Technical Bulletin 189

03.2018

Description: Steering Lock Grub Screw

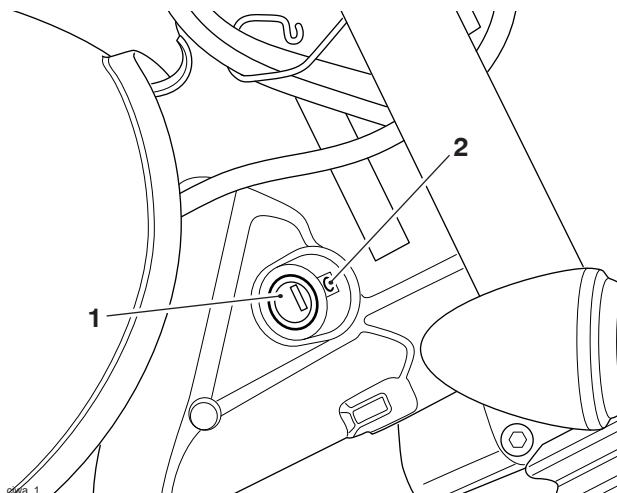
The torque figure has changed. If loosened or removed for any reason the encapsulated fixing(s) must be replaced.

1. Steering lock

2. Grub screw

Tighten the grub screw to **0.7 Nm**.

Description: Handguard to Bracket Fixing

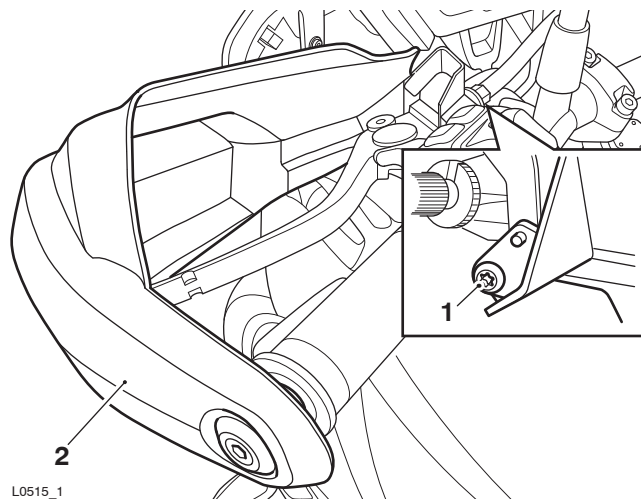
New handguard to bracket fixings have been introduced to the above models from VIN 882027 (all markets except Brazil and India) and VIN 882725 (Brazil and India markets only) with a new torque figure. The new fixings are retrofittable.

The torque figure has changed. If loosened or removed for any reason the encapsulated fixing(s) must be replaced.

1. Handguard to bracket fixing

2. Handguard

Tighten the fixings to **6 Nm**.

Item: 189.6
Description: Fuel Pump Wires
Model Affected: Tiger Sport from VIN 750470

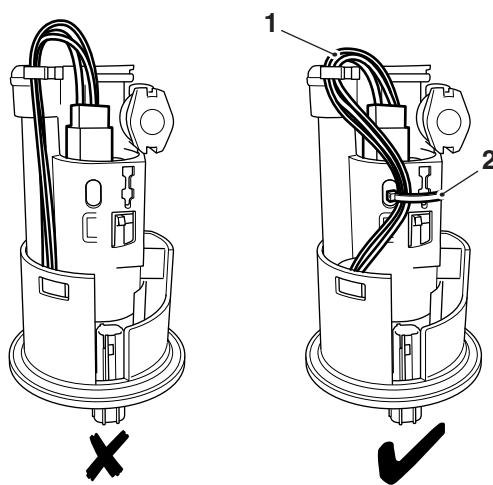
Some of the above motorcycles have experienced incorrect fuel level readings caused by the fuel pump wires fouling the fuel level sender. For motorcycles displaying this problem, this can be rectified by the addition of a cable tie, fitted as described below.

1. **Correct wire positions**
2. **Cable tie**

1. Remove the fuel pump and filter assembly as described in the Service Manual.
2. Ensure the fuel pump wires are positioned as pictured.

3. Install the cable tie in the position shown.
4. Install a new sealing ring to the fuel pump assembly as described in the Service Manual.
5. Refit the fuel pump and filter assembly as described in the Service Manual.

Description: Fuel Level Sender Wires

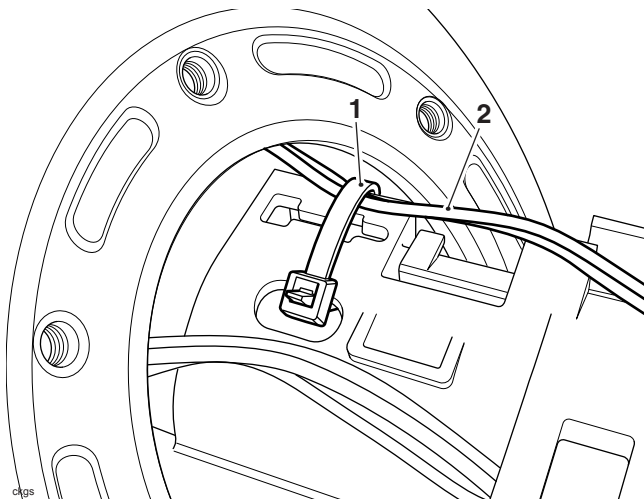
Some of the above motorcycles have experienced incorrect fuel level readings caused by fuel level sender wires interfering with the fuel level sender arm. For motorcycles displaying this problem, this can be rectified by the addition of a cable tie, fitted as described below.

1. **Cable tie**
2. **Fuel level sender wires**
4. Install the cable tie in the position shown.

Routing the fuel level sender wiring over the fuel level sender arm will prevent the sender arm from moving through its full range of movement, causing incorrect fuel gauge readings.

1. Remove the fuel pump and filter assembly as described in the Service Manual.
2. Install a new sealing ring to the fuel pump assembly as described in the Service Manual.
3. Ensure the fuel level sender wires are positioned as pictured.

5. Refit the fuel pump and filter assembly as described in the Service Manual, ensuring that the fuel level sender wiring is not routed over the fuel level sender arm.

Description: Front Master Cylinder Reservoir Cap Screws

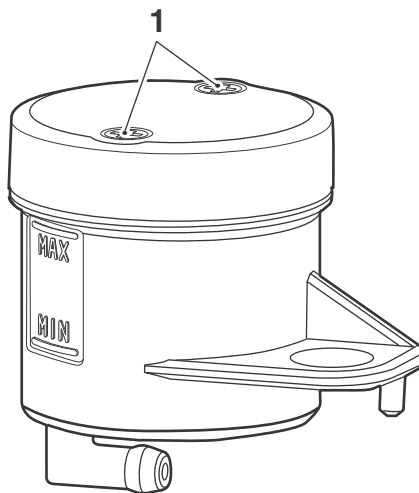
The torque figure has changed. If loosened or removed for any reason the fixing(s) must be torqued as required.

If the master cylinder reservoir cap screws are over tightened this can result in a brake fluid leak. A dangerous riding condition leading to loss of motorcycle control and an accident could result if this warning is ignored.

1. Front master cylinder reservoir cap screws

Tighten the fixings to **0.7 Nm**.

Item: 189.9
Description: Belly Pan to Rear Mounting Bracket Fixings
Model Affected: Street Triple RS

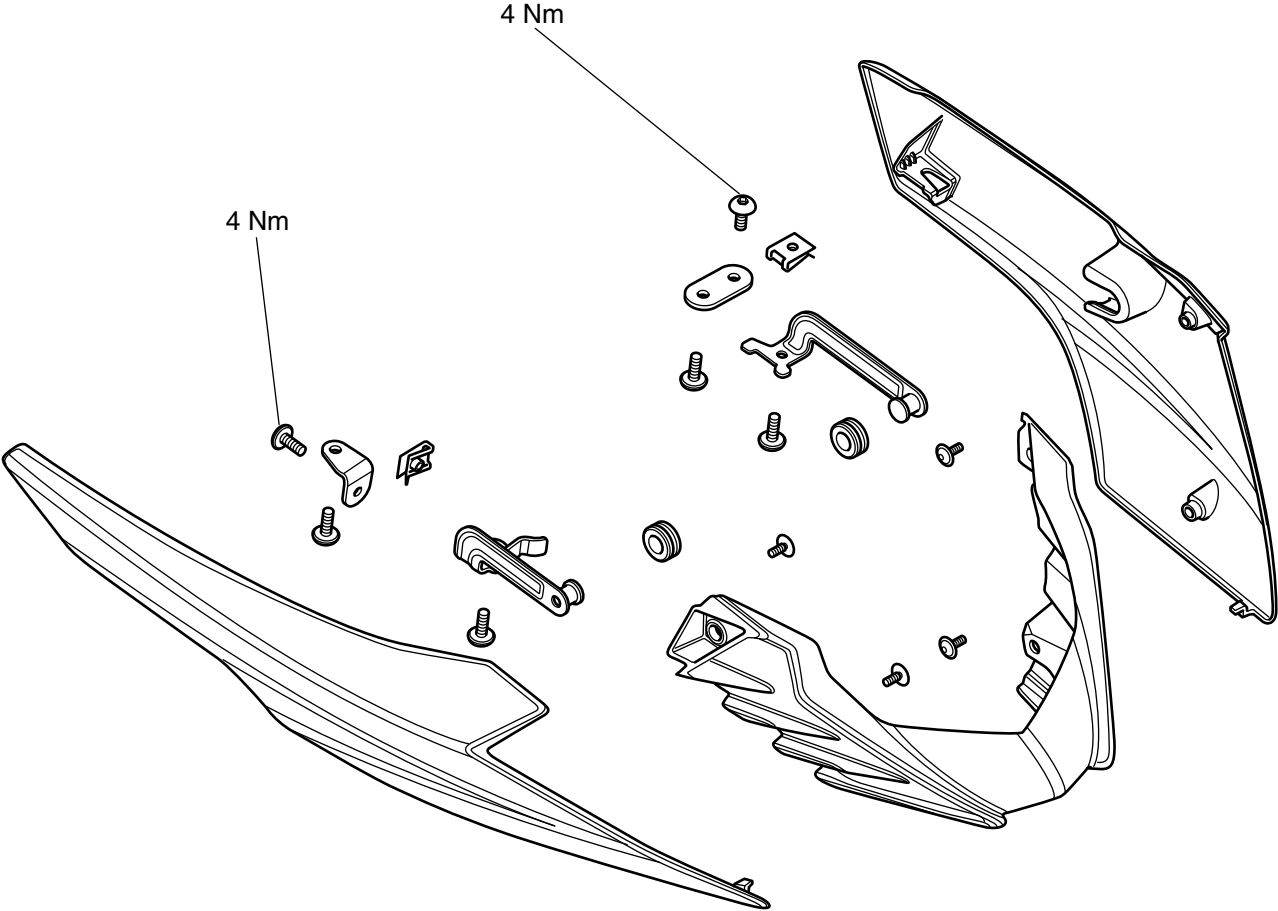
The belly pan to rear mounting bracket fixings have been replaced with encapsulated fixings on the above model from VIN 887970 (all markets except Brazil and India) and VIN 888287 (Brazil and Indian markets only). The new fixings are retrofittable. If loosened or removed for any reason the encapsulated fixing(s) must be replaced.

Application	Torque (Nm)	Notes
Belly pan to rear mounting brackets	4 Nm	Fit new fixing(s) if loosened or removed
